## **SECTION 9.0 – RESPONSE TO COMMENTS**

This section includes all comments received on the Draft EIR during the 90-day public review period between October 23, 2013 to January 21, 2014 (45-day minimum per CEQA, plus 30 days per LACFCD extension, and an additional 15 day LACFCD extension). No new significant environmental impacts or issues were raised during the public review period beyond those already identified in the Draft EIR for the Devil's Gate Reservoir Sediment Removal and Management Project. During this public review period a total of 251 comment letters were received.

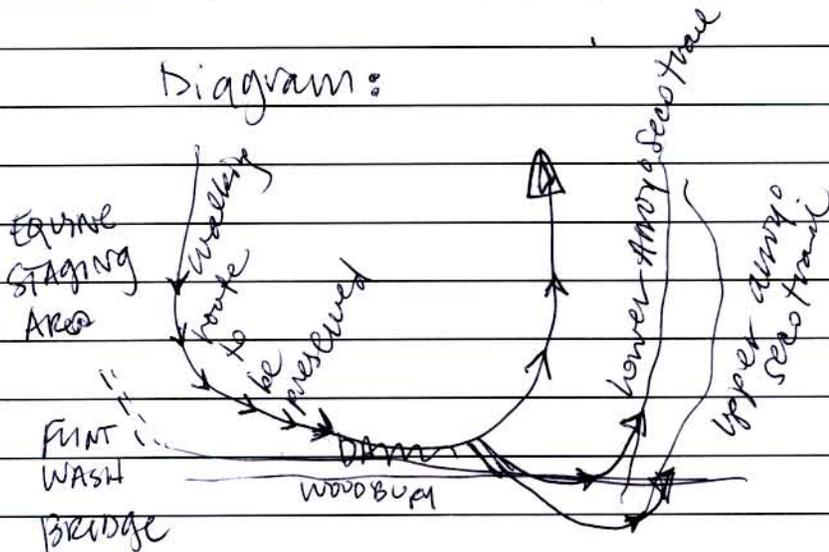
① PLEASE ALLOW USE OF FUNT WASH BRIDGE & TOP OF DAM WALKWAY FOR CONTINUAL FOOT TRAFFIC TO ALLOW THE WALKING/HIKING LOOP TO BE PRESERVED EVEN DURING THE DAILY HAULING TOURS.

IS THERE AN ALTERNATIVE WALKING/HIKING TRAIL PROPOSED TO enable the whole loop to be accessed/Utilized?

**Attachment 2**  
**City of La Canada Flintridge**  
**SENSITIVE RECEPTOR LOCATIONS**

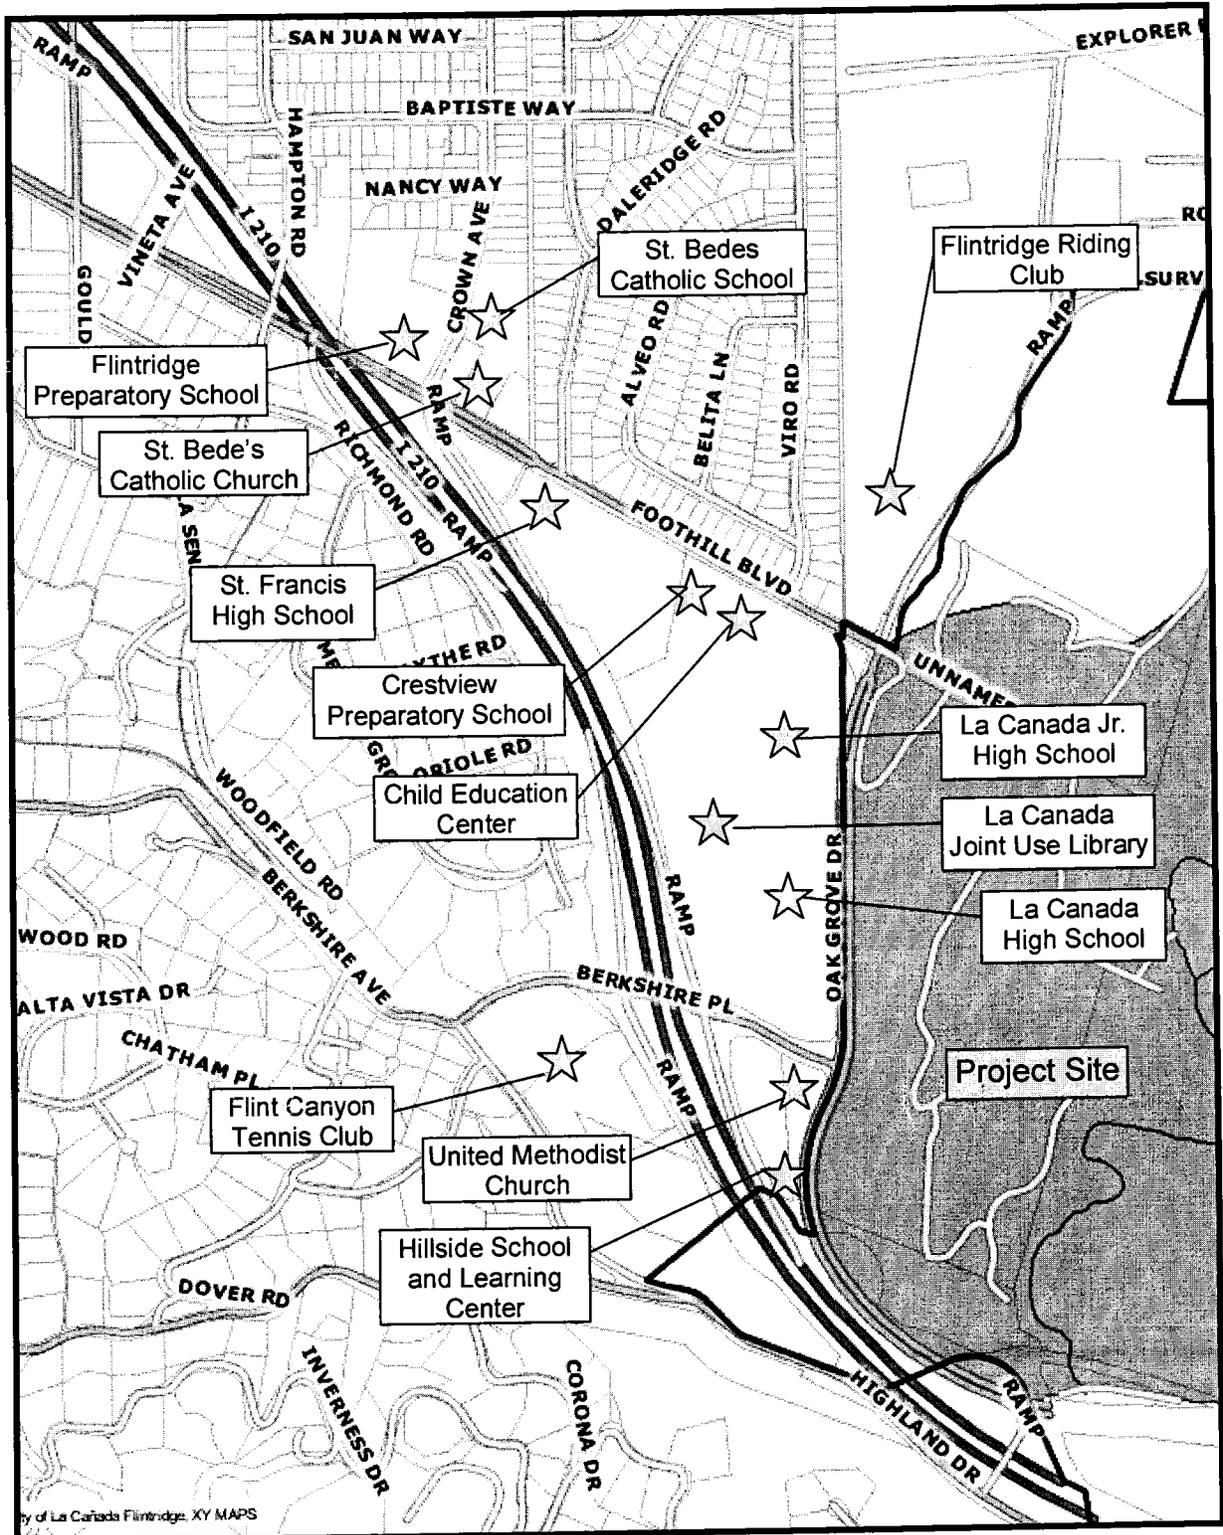
Overall, the City supports the removal of built-up sediment from the Devil's Gate reservoir to restore flood protection for the surrounding community. However, the City strongly urges the County to (1) take a "kinder-gentler" approach and minimize the amount of sediment removed, (2) extend the project to reduce the potential environmental impacts further, and (3) not utilize Berkshire Avenue/I-210 ramps as a result of all of the schools and other sensitive receptors and rather utilize the Winsor/Arroyo haul route. The City feels that all of the goals of the project are attainable even if it takes a little longer to accomplish.

Figure 8-27 Graph of Historical Sediment Storage at Devil's Gate Reservoir

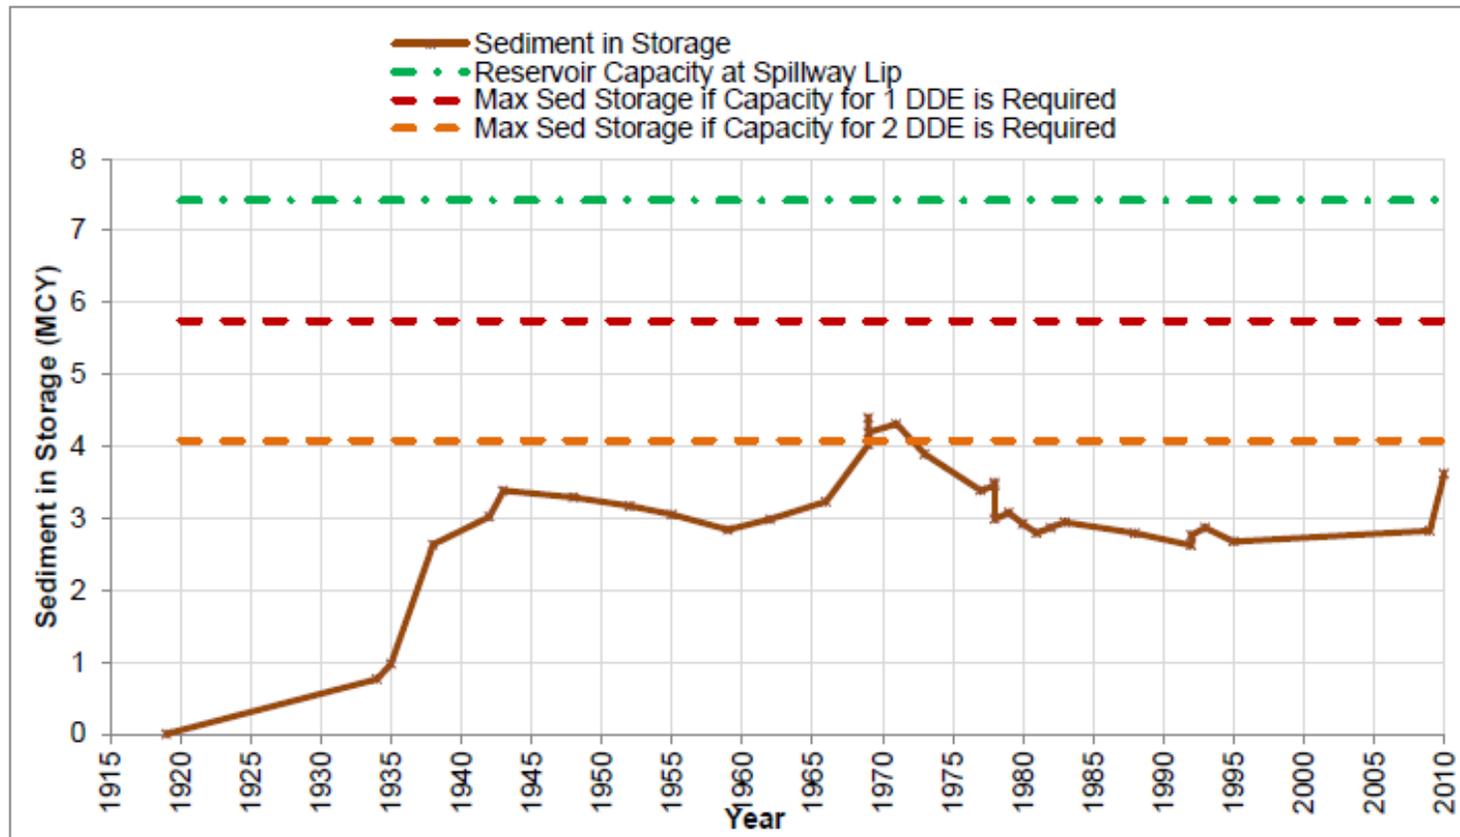
- According to LACDPW Sediment Management Strategic Plan 2012-2032 (<http://dpw.lacounty.gov/lacfd/sediment/stplan.aspx>), Table 2-1 Reservoirs in the Flood Control District (Exhibit 4), the remaining capacity is 3.7 mcy (47%), almost 2 Design Debris Events (DDEs). In addition, the Strategic Plan Figure 8-27, Graph of

- ? How has it been possible to keep the areas south of the dam safe for over 75 years while still retaining between 2.62 mcy and 4.40 mcy in storage behind the dam (Exhibit 8, Sediment Management Strategic Plan, Devil's Gate Reservoir Historical Sediment Accumulation and Removal, Table 8-12)?

Exhibit 13 – Photo of Hahamongna Watershed Park – November 7, 2010 – Courtesy of Petrea Burchard

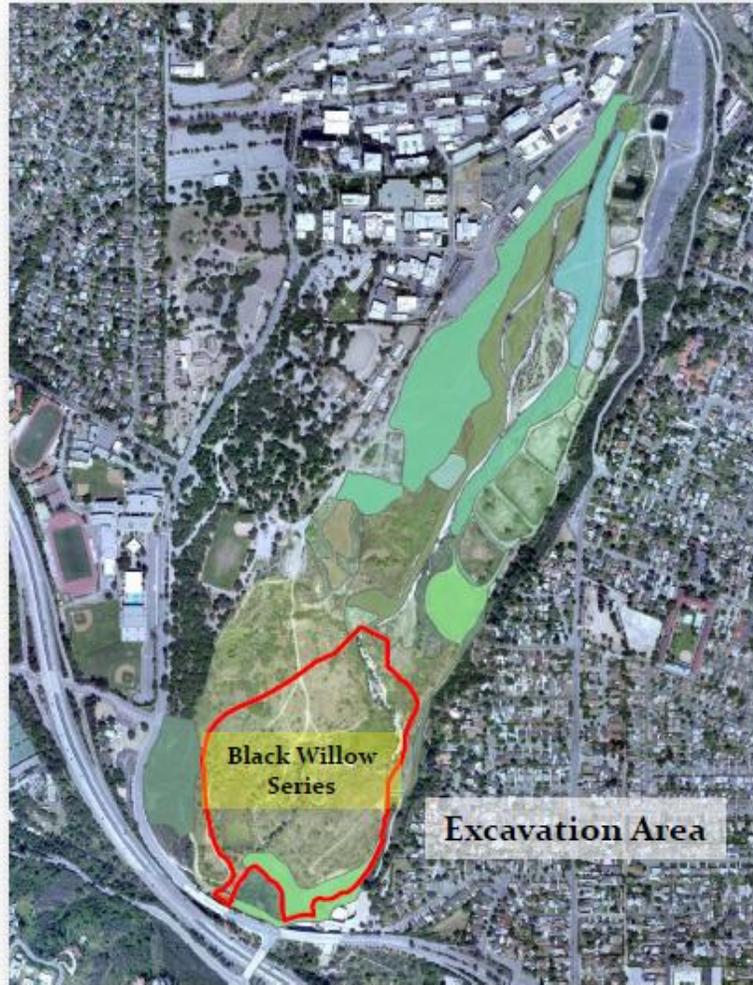
area ( Figure 3.4-2) and the 2011 picture of the project area (Figure 3.4-3) were taken during the month of February when the willow trees in Hahamongna are dormant. A photo taken on November 7, 2010 (Exhibit 13) shows that the willow trees behind the dam were very much alive. The final EIR must present project area photos that accurately reflect the current state so as to not give the misleading impression that the trees behind the dam are dead. Most of the trees behind the dam, primarily willows, not only survived the Station Fire but flourished.

Comment 215-17  
continued

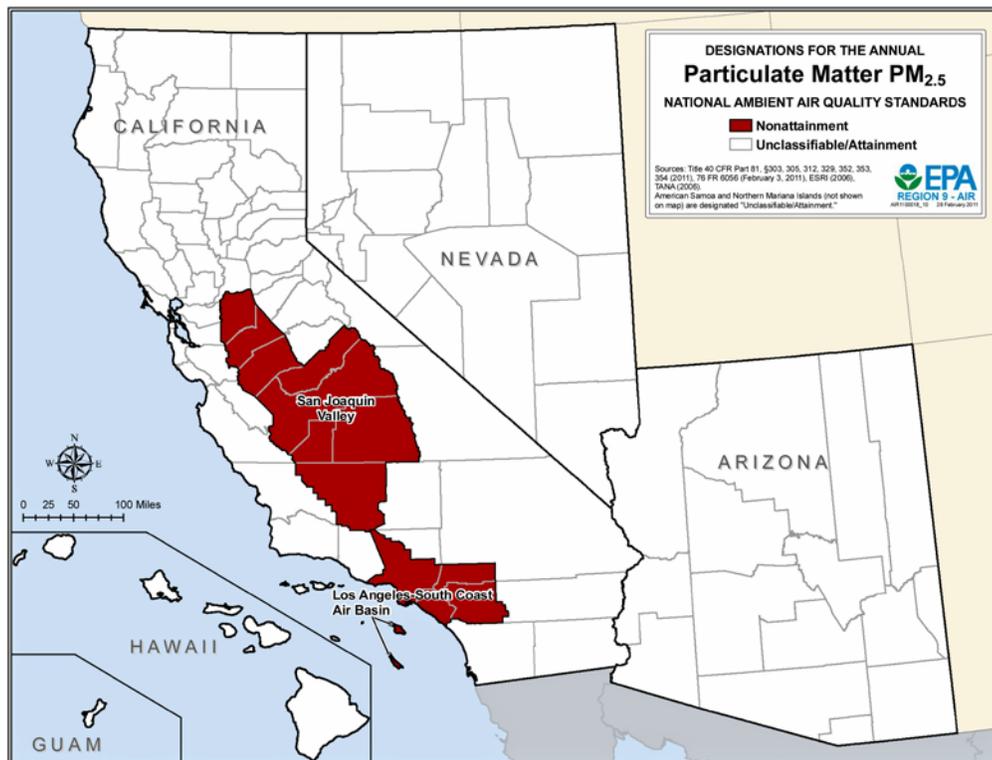
Note 2 Idling trucks must be considered because these double dump trucks will be unloaded much more rapidly than they can be filled; idling produces significant emissions that are not included in the DEIR calculations. These extra

emissions will affect those nearest to the Hahamongna site. That's why we need real pollution measurements in addition to predictions of pollutants.
